**NOTICE OF DECISION**  
**Fairfield by Marriott Inn & Suites – 900 Block N Brutscher Street**  
**Design Review/Variance – DR222-0001/VAR22-0002**

Fairfield by Marriott Inn & Suites - Design Review/Variance – DR222-0001/VAR22-0002

REQUEST: Development of a 79-room hotel

Newberg • Oregon • USA

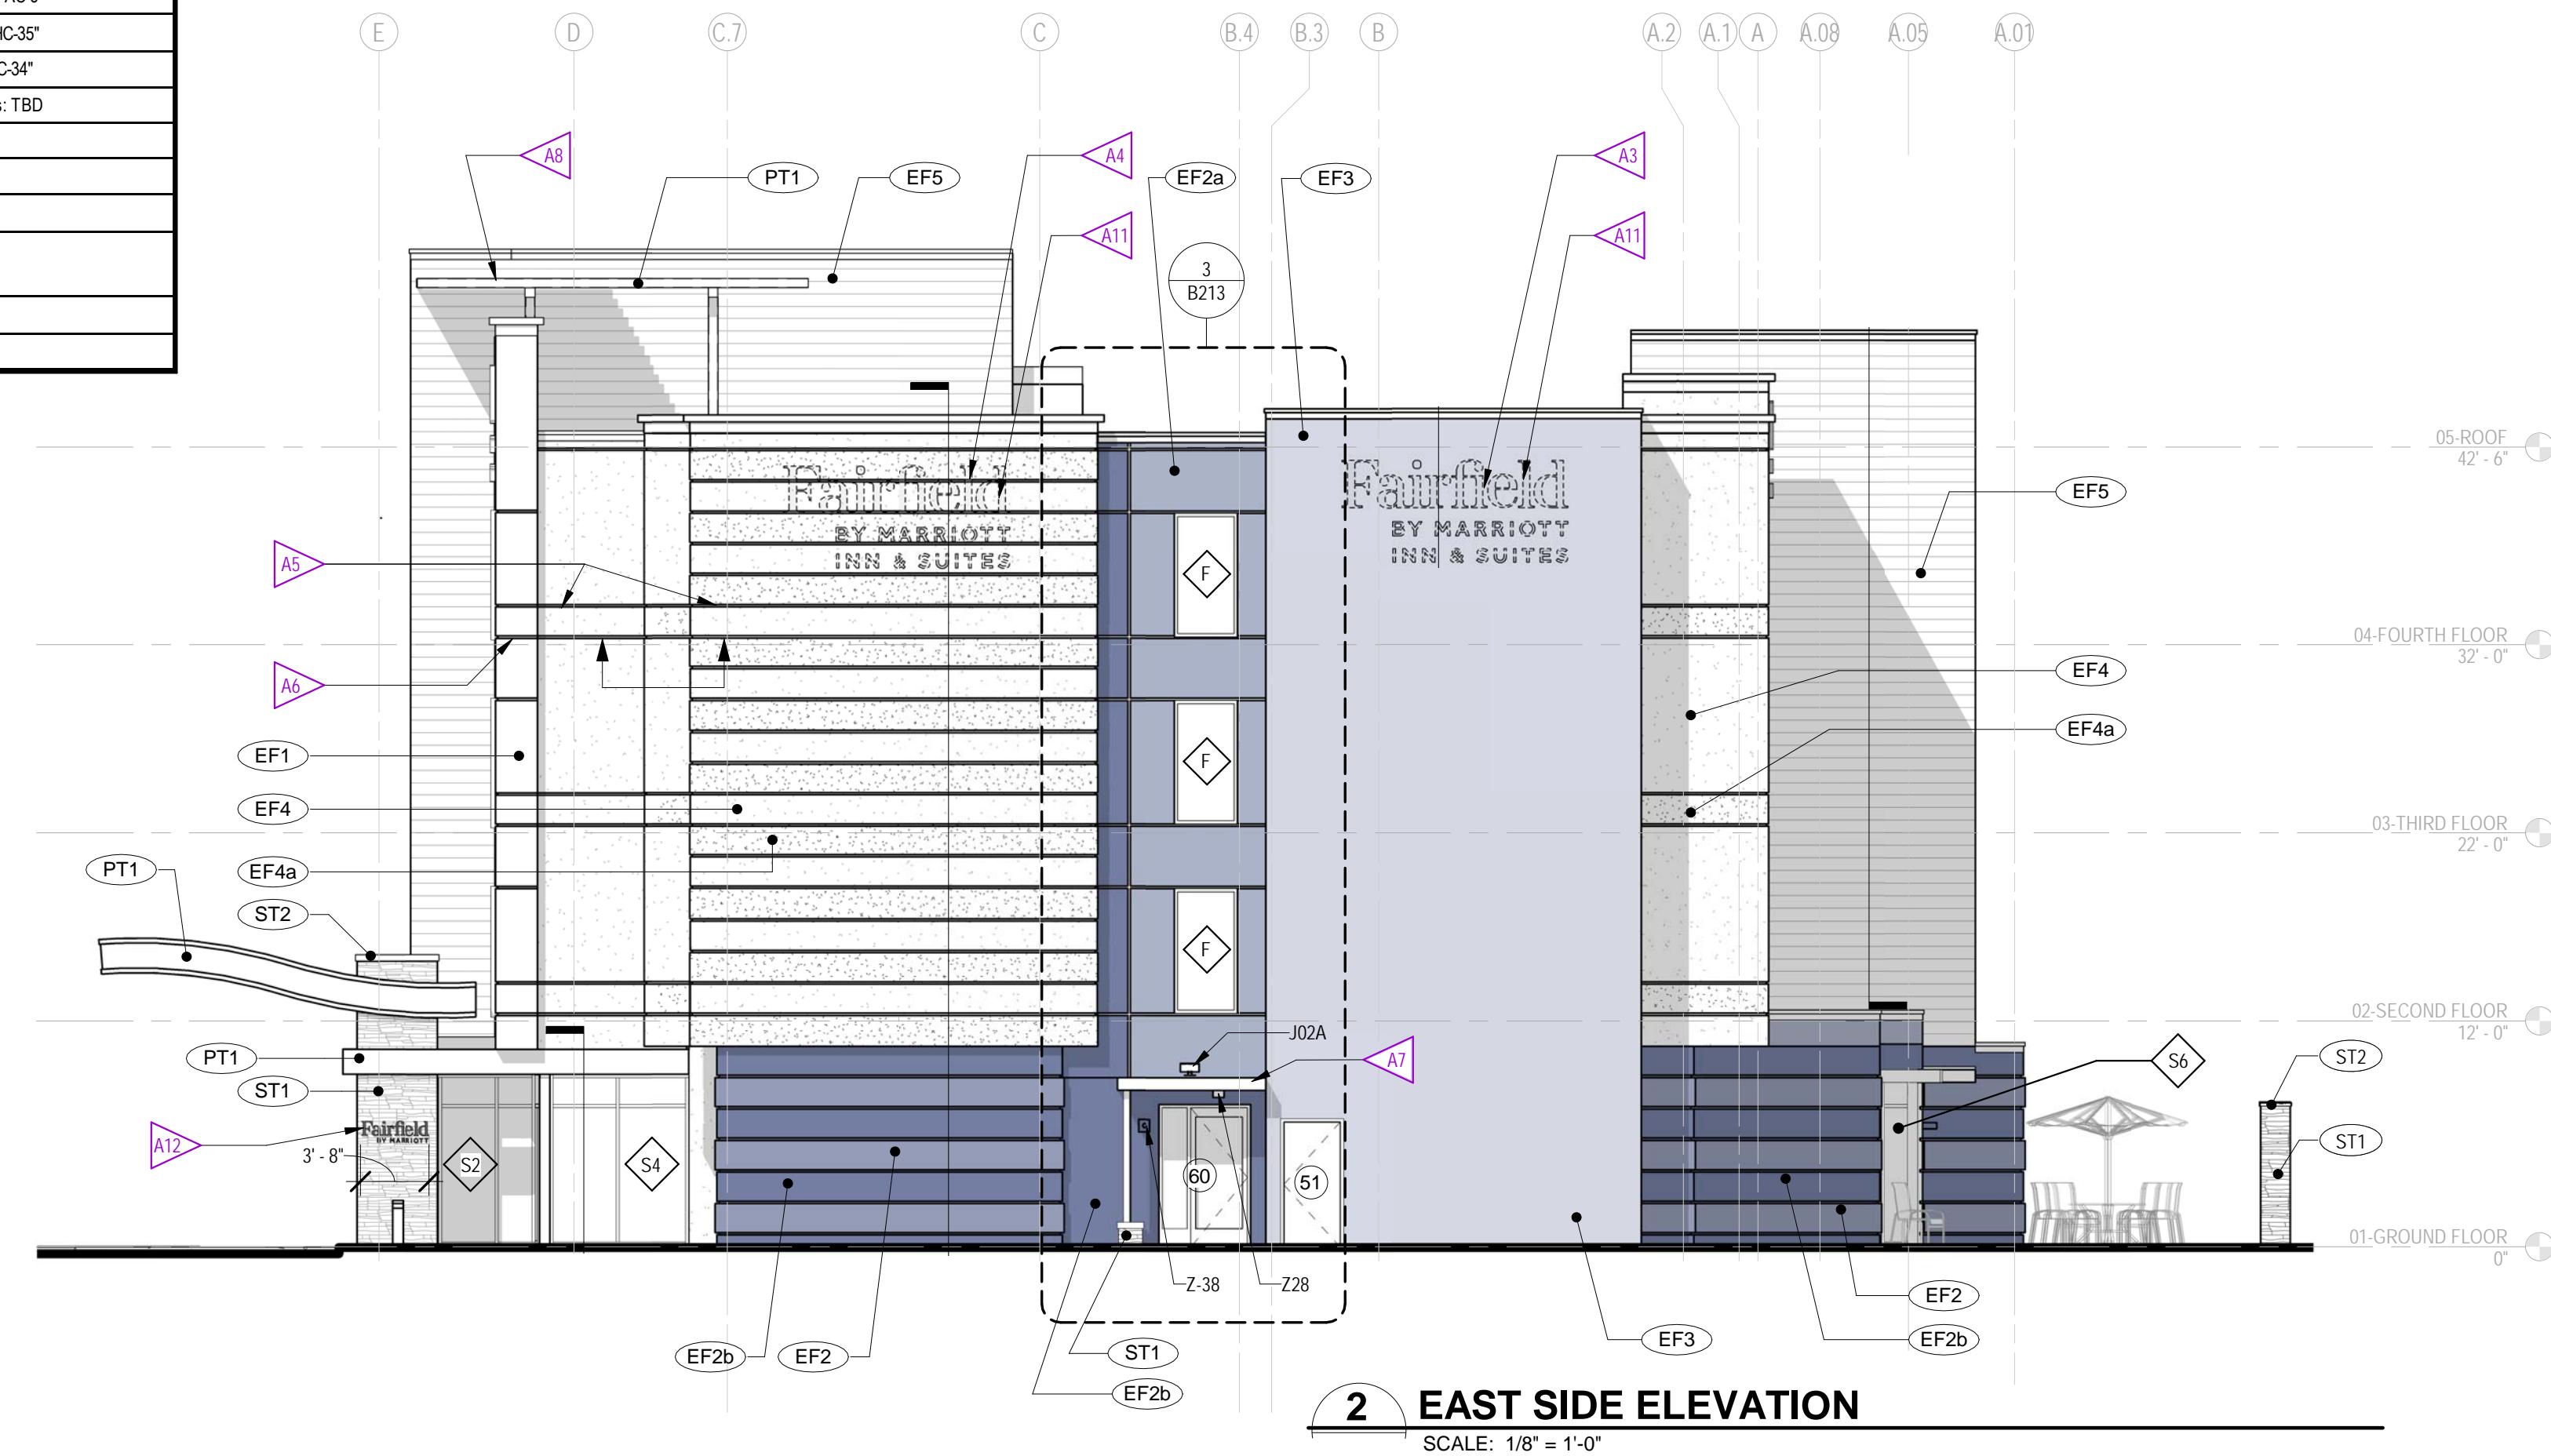
**Finding:** The proposed hotel is a 4-story structure with 79-rooms. The architecture of the building incorporates a variety of building materials including fiber cement siding, wood plank siding, stone veneer, stone coping, and metal. The roof line has varying elevation heights to break up the building mass. In addition, the horizontal planes of the building include recess and relief to break up the building mass along with windows on the four elevations. A porte cochere (canopy) is provided at the main building entrance. The building will be painted a series of colors as detailed on the Exterior Finish Schedule on Sheet A211.
